R.W. CORKERY & CO. PTY. LIMITED

TO: Genevieve Seed EMAIL: genevieve.seed@planning.nsw.gov.au
ORGANISATION: Department of Planning & Environment DATE: 22 January 2016
COPY: Gales-Kingscliff Pty Ltd REFERENCE: 617
Tweed Shire Council
NO. OF PAGES (including attachments): 5
SUBJECT: Cudgen Lakes Sand Quarry – Response to Council Comments

Alternative office locations with water tank

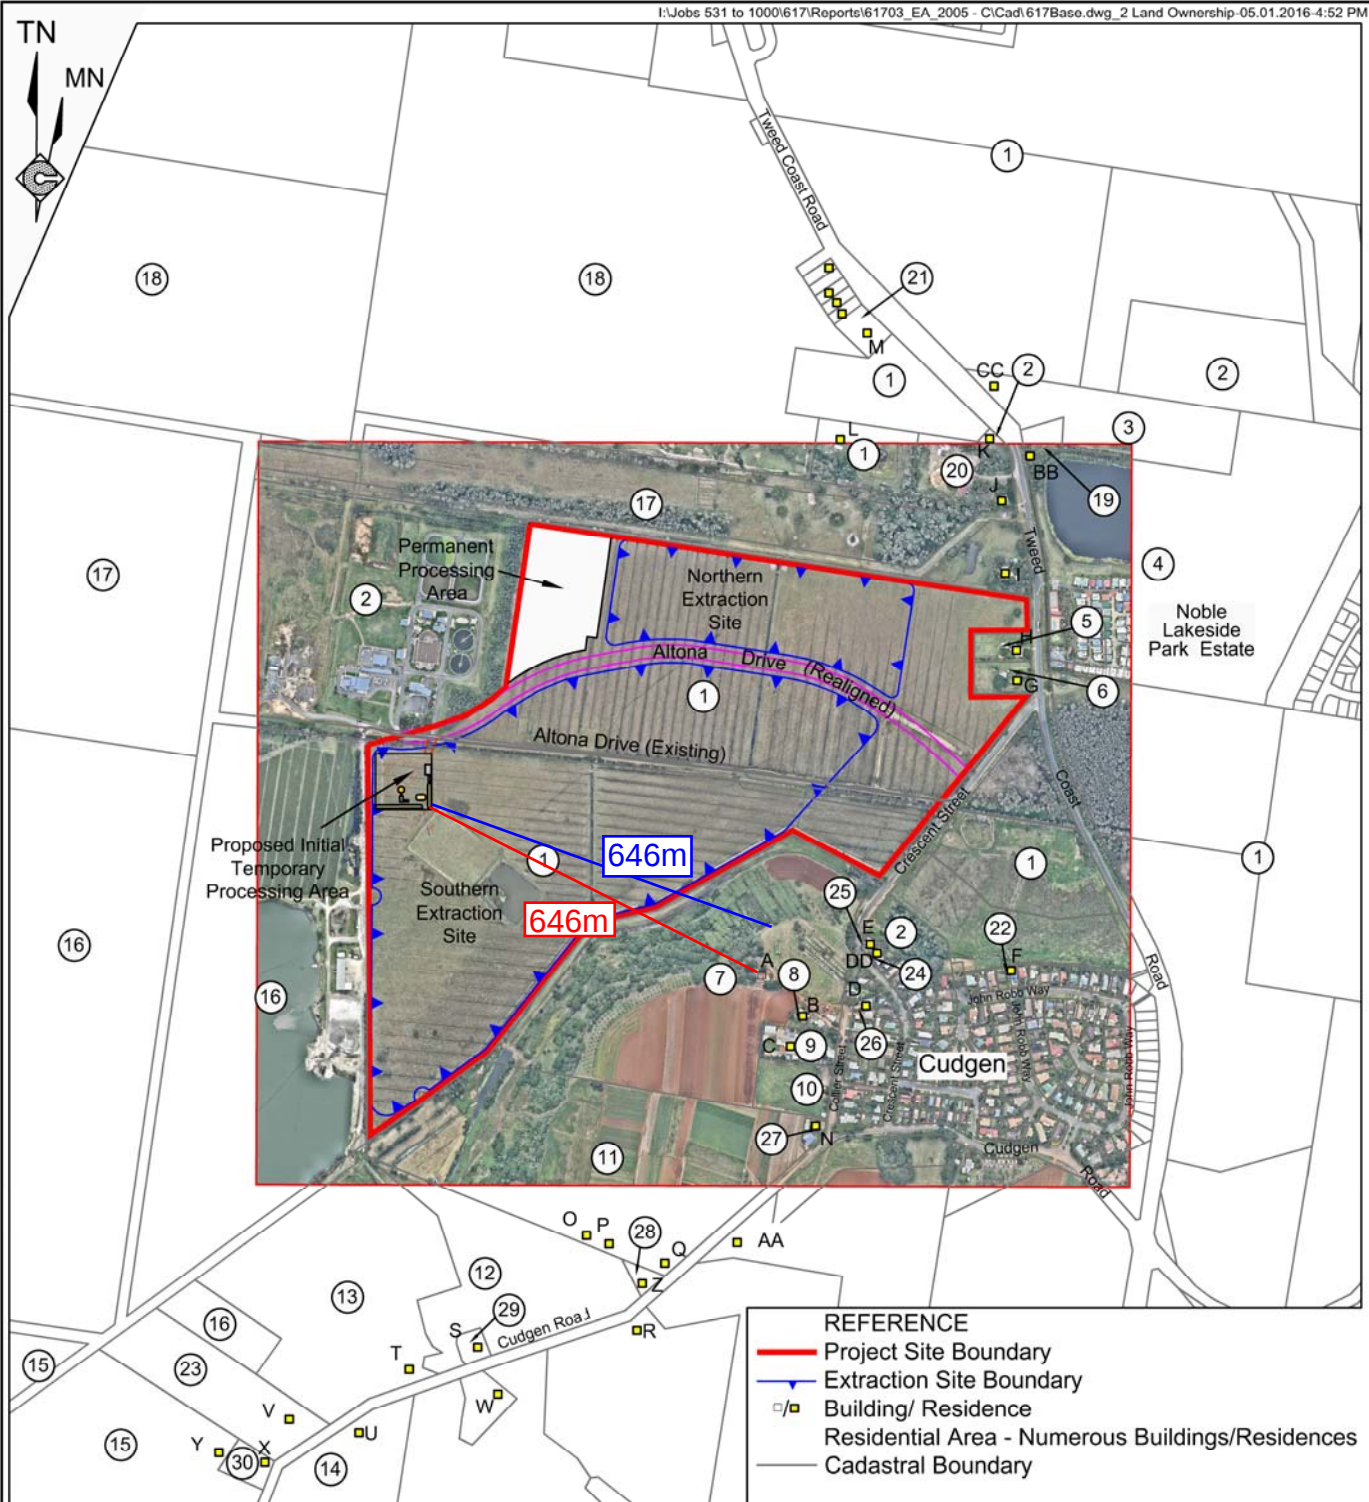
Please see attached a marked up plan showing our measurements of the existing office location and two alternative locations. As can be seen, it would be possible to maintain the office outside the 200m buffer zone on either the eastern or western side of the Initial Processing Area. Gales therefore has no objection to requiring that the Initial Processing Area office meet the 200m buffer zone and ventilation requirements of the Development Control Plan.

Figure 2
SURROUNDING LAND OWNERSHIP
AND PRINCIPAL RESIDENCES

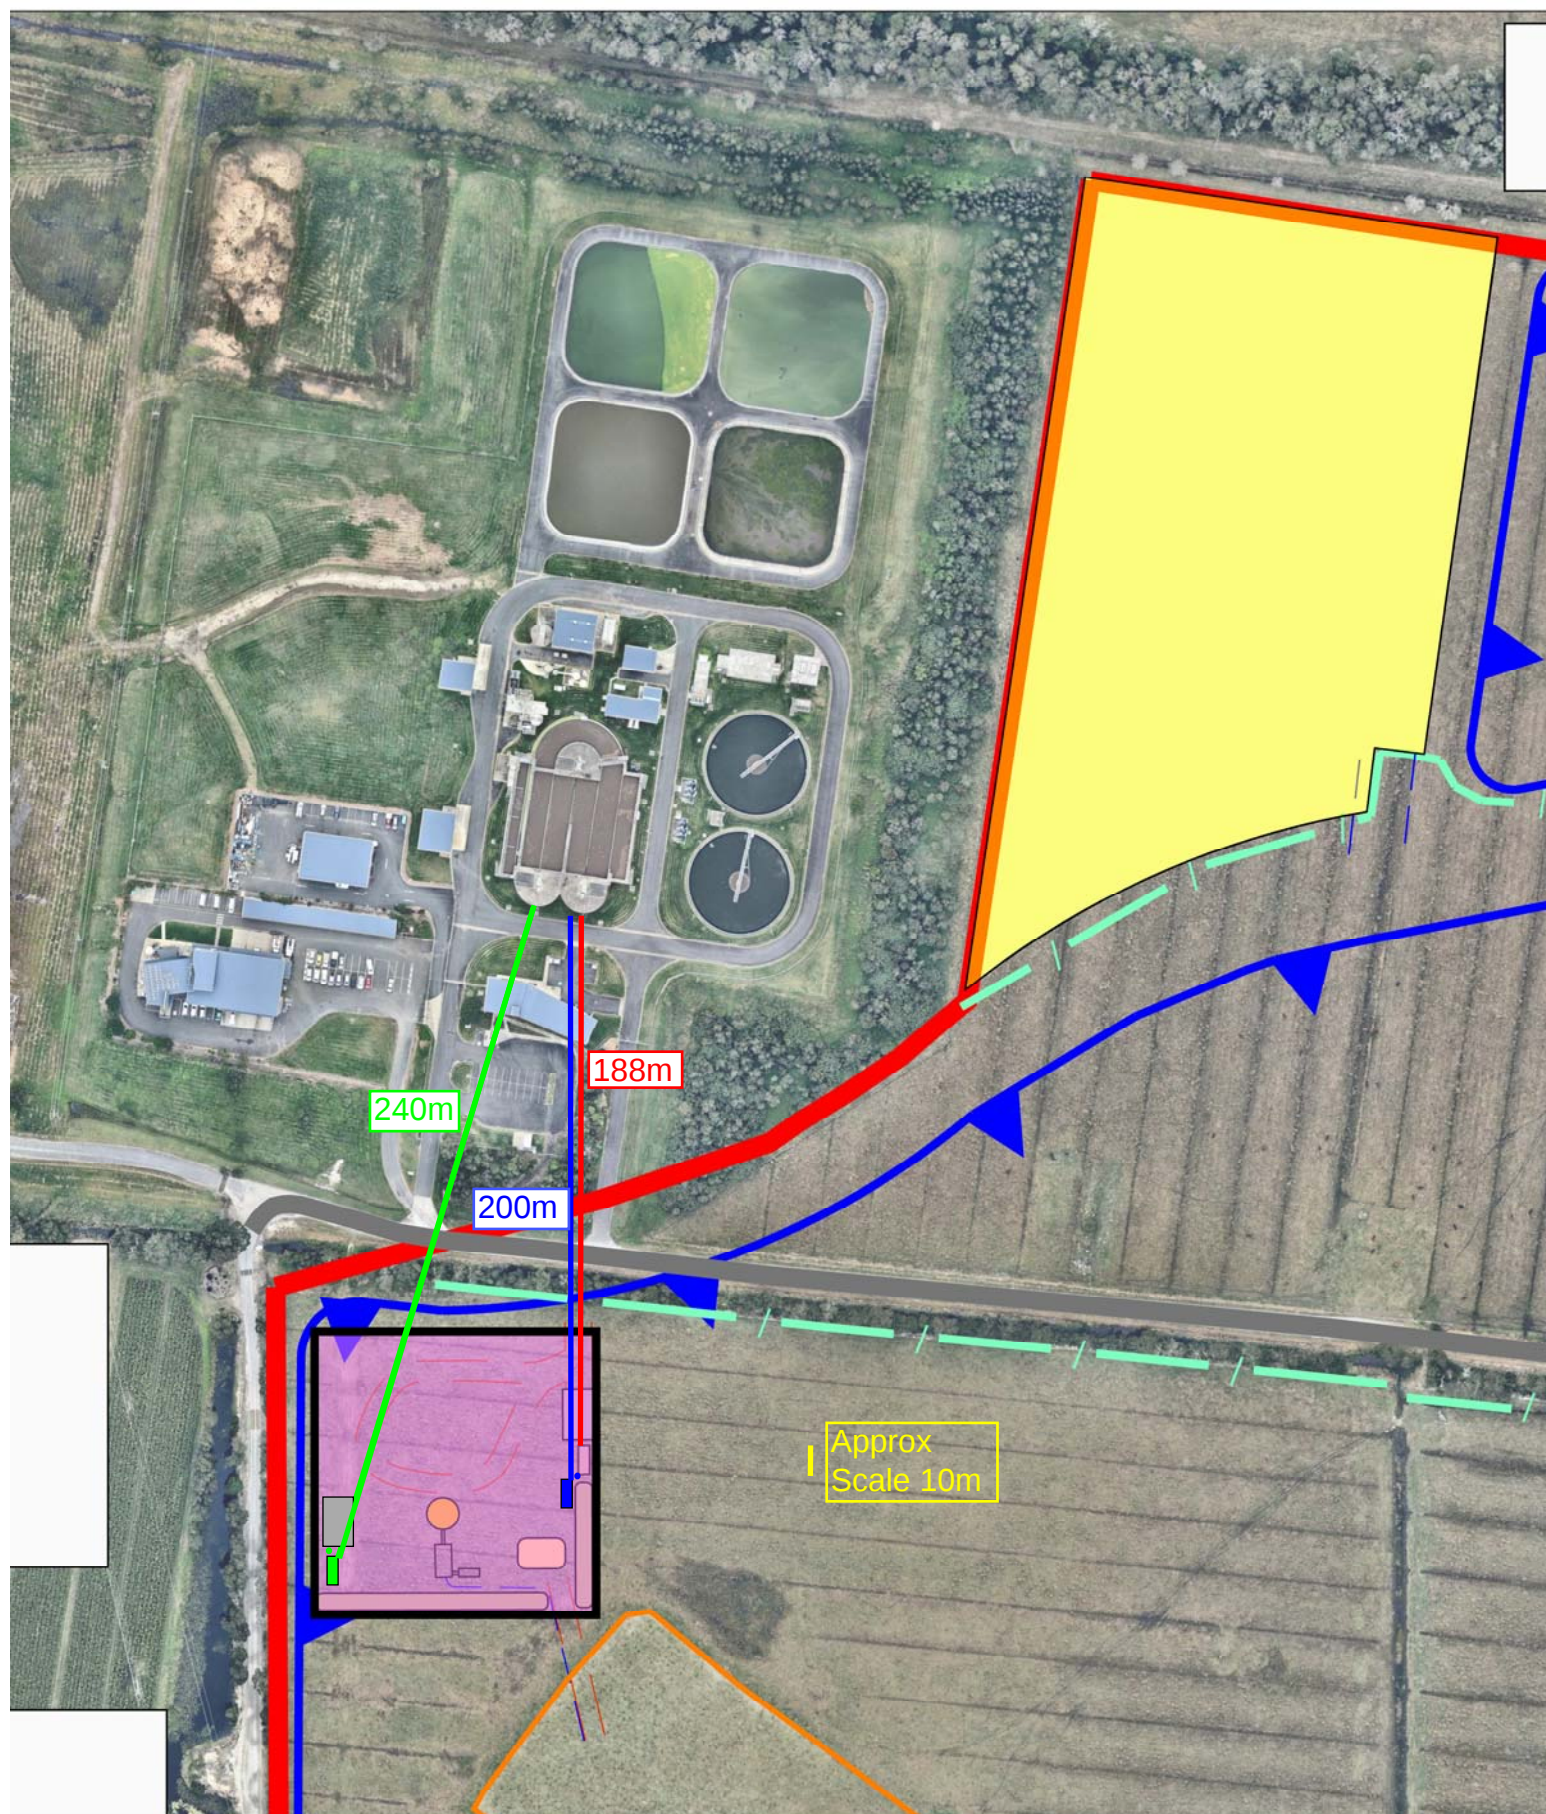
It is noted that the noise assessment for the Initial Processing Area considers impacts to Residence A which is located approximately the same distance as the closest subdivided block within the approved subdivision (see attached marked up plan). Therefore Residence A is representative of the adjacent subdivision. Given it was assessed that compliance would be achieved, no further assessment is considered necessary. Similarly, the air
